Here are my sketches of the ground floor rooms and windows in relation to the two alleys between my house, No. 99, and No. 101; and the impact that the two plans previously lodged with Camden and the plan sent by the Architect to the joint surveyor as the intended plan, would have on No.99. (This is item 2 on the list in my letter to you.)

Please find attached my reply, as the owner/occupier of 99 Constantine, regarding the planning applications by my neighbours at 101 Constantine Road.

Application ref: 2013/6391/P  
Associated ref: 2013/6304/P  
Date: 12 November 2013

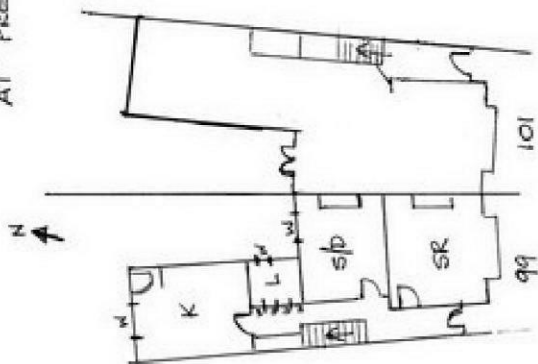
12. Compass set on the outside window sill of the study, confirming that the room looks north down the alley. Hence, the light available is ambient, reflected light, not direct light.

AS PROPOSED UNDER  
PLANNING APP.  
2013/6391/P

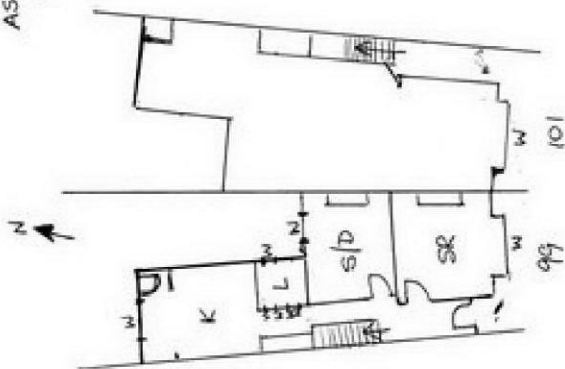
Separately, you have been asked to assess Application 2013/6391/P. Were this the only plan, I would regard it as a fairly satisfactory compromise. It will reduce the ambient light available to No.99 somewhat, but probably not greatly; it will reduce the outlook and increase the sense of enclosure for No.99, but again not as much as the 2009 plan; it is long but not too high. It also abuts but does not incorporate the boundary wall, which is also important. So, were this the only plan, I would probably adjudge it acceptable.

AS PROPOSED UNDER PLANS  
SENT TO SURVEYOR

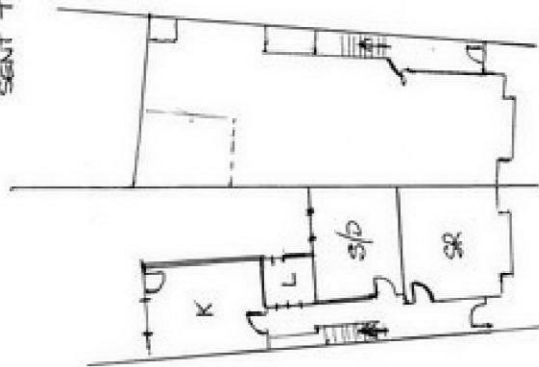
However, it is not the only plan. There is also 2013/6394/P and there is the plan sent to the surveyor, Stephen Stark, as the intended plan, which re-incorporates 2013/6394/P back into 2013/6391/P, as you will see from the plans sent to me which I am forwarding to you.

It goes without saying that if both 2013/6391/P and 2013/6394/P are both granted and then the neighbours at 101 try to build both according to their intended plan, the effect on the lighting and amenity for 99 would be considerable. I would suggest that it may be overdevelopment. The exterior facing 99 would certainly be bulky and high; it would deprive No.99 of light to the habitable rooms and the corridor; it would entail a loss of outlook; and it would considerably increase the sense of enclosure.

Drawing Title:  
Proposed Floor Plans  
Drawn:  
R Lasserson  
Scale:  
1:50 @ A1  
Date:  
28.01.2011  
Dwg No:  
CR.01.07 J  
HARTLEYS PROJECTS LTD  
PO BOX 43391  
London N6 1SZ 020 7704 8272

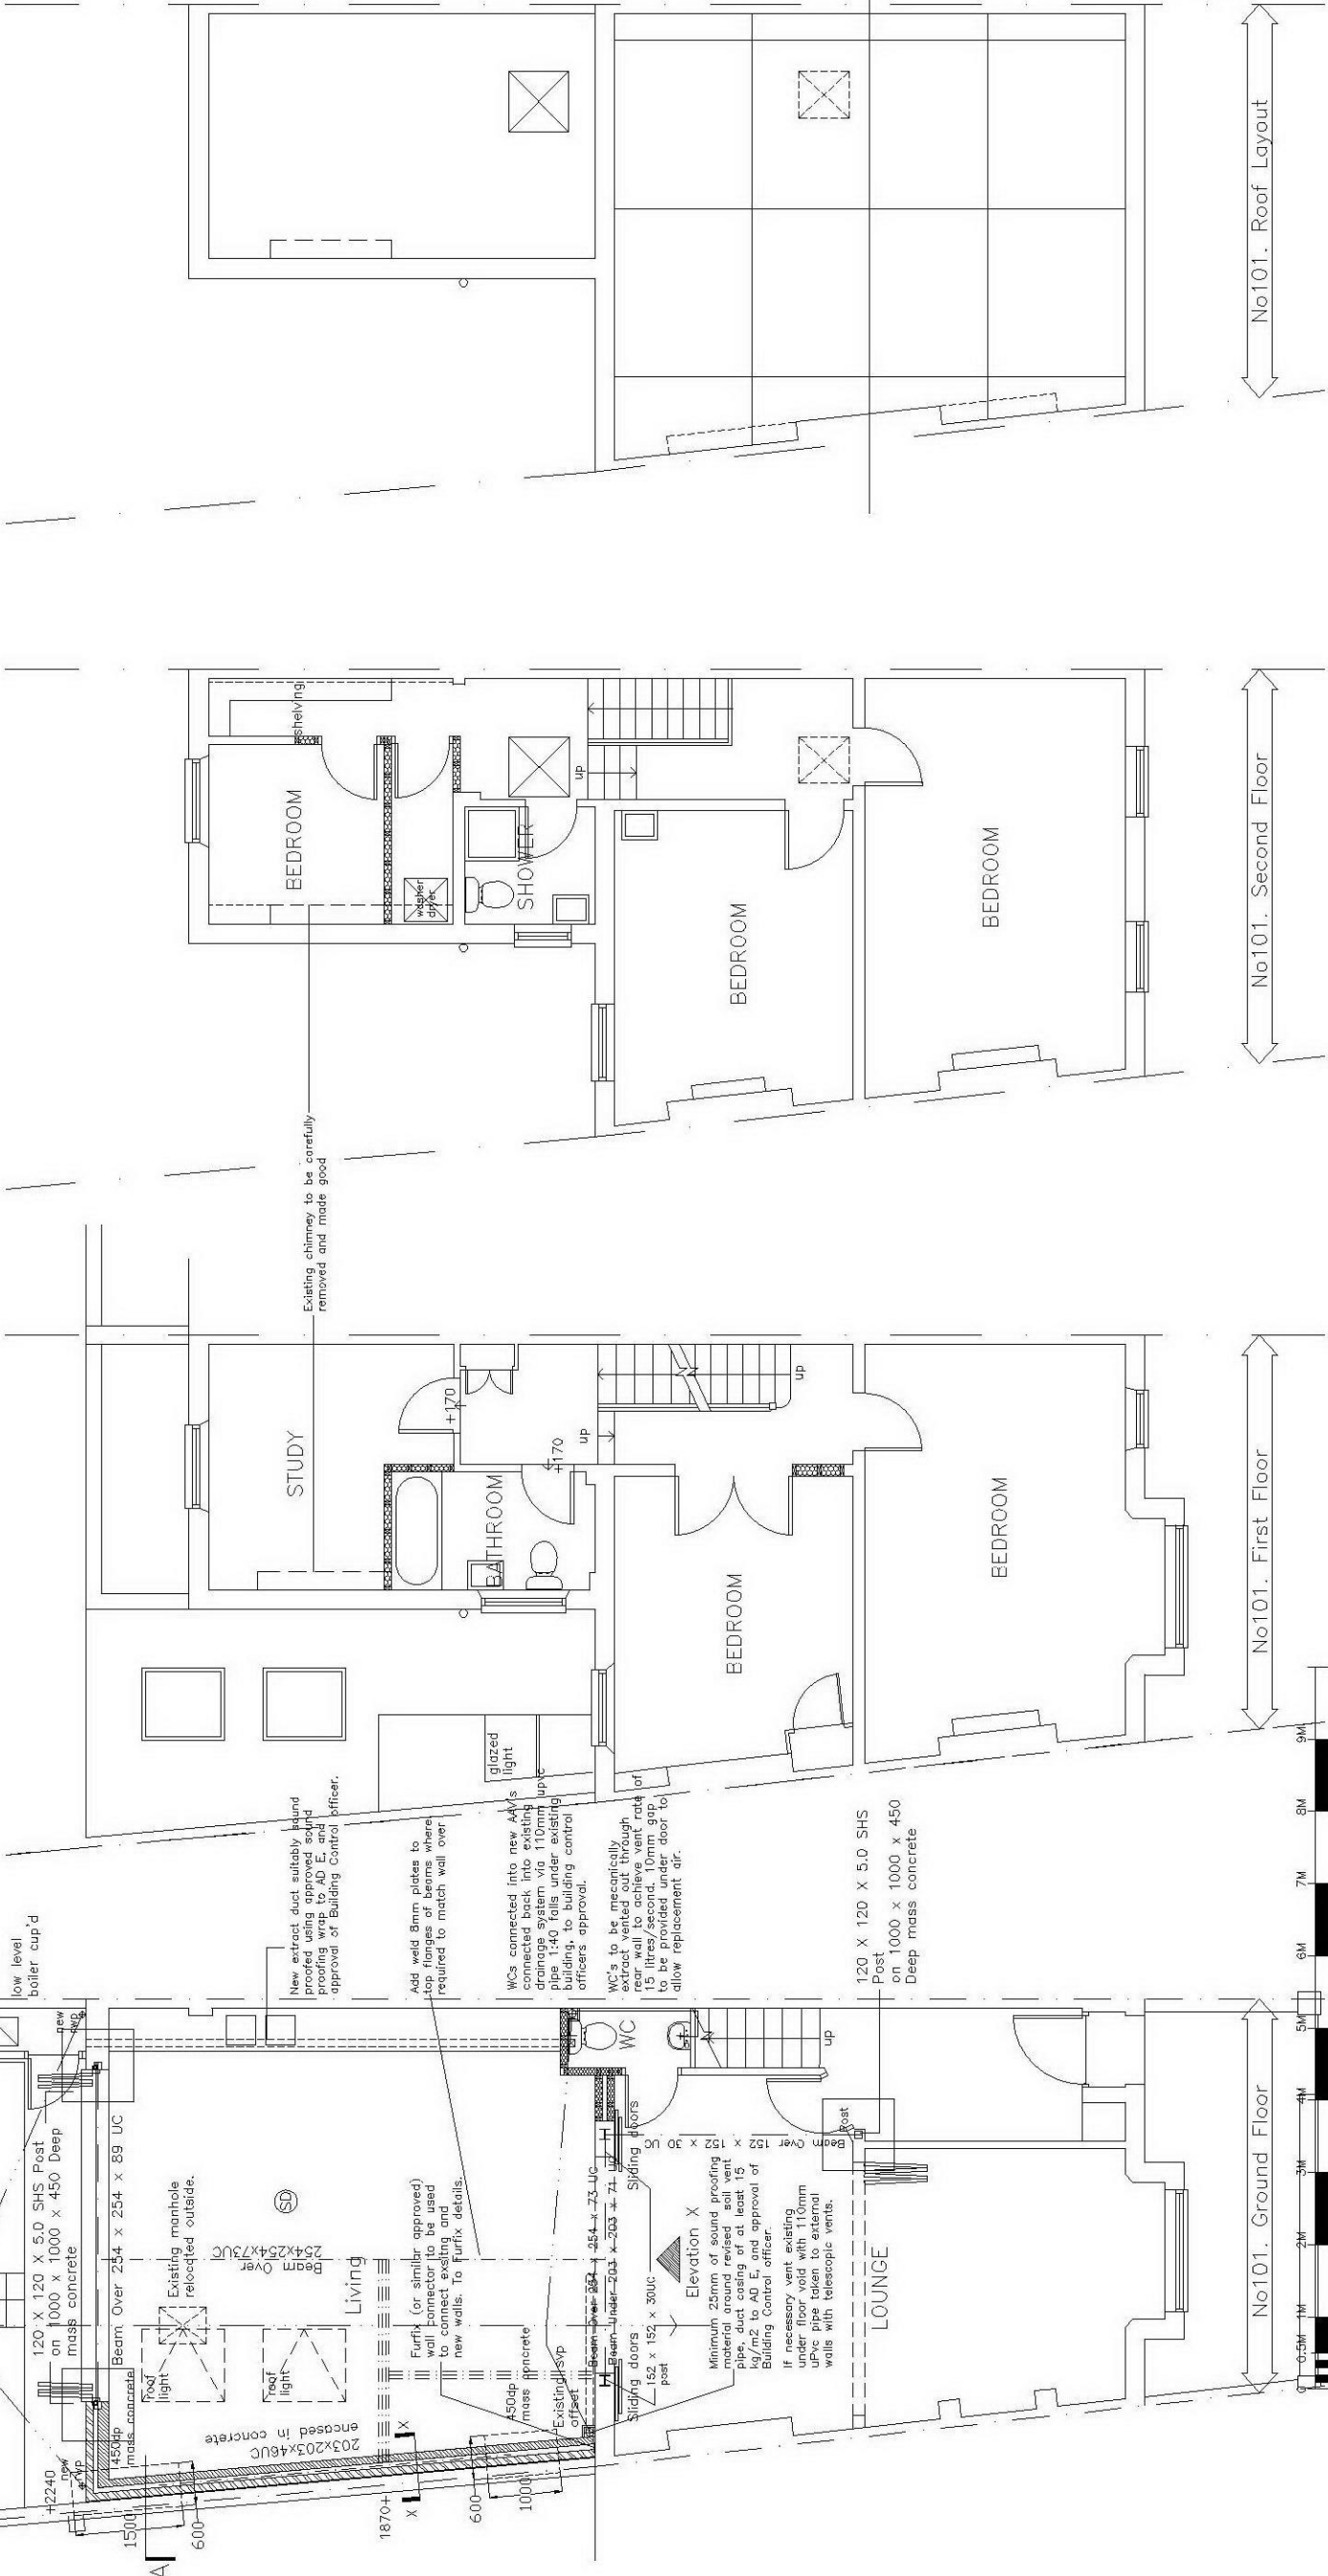
The architect for 101, Simon, sent the surveyor on 9 October architectural drawings which were neither those which you have as 2013/6391/P nor 2013/6394/P but are a third set. I attach these to this letter.

*I note that you have submitted two new planning applications 2013/6391P and 2013/6394/P. These bear no relation to the drawing which your Architect sent me on 9 October 2013 and which in respect of party wall matters you asked me to review. Please can you clarify matters to avoid my wasting time.*
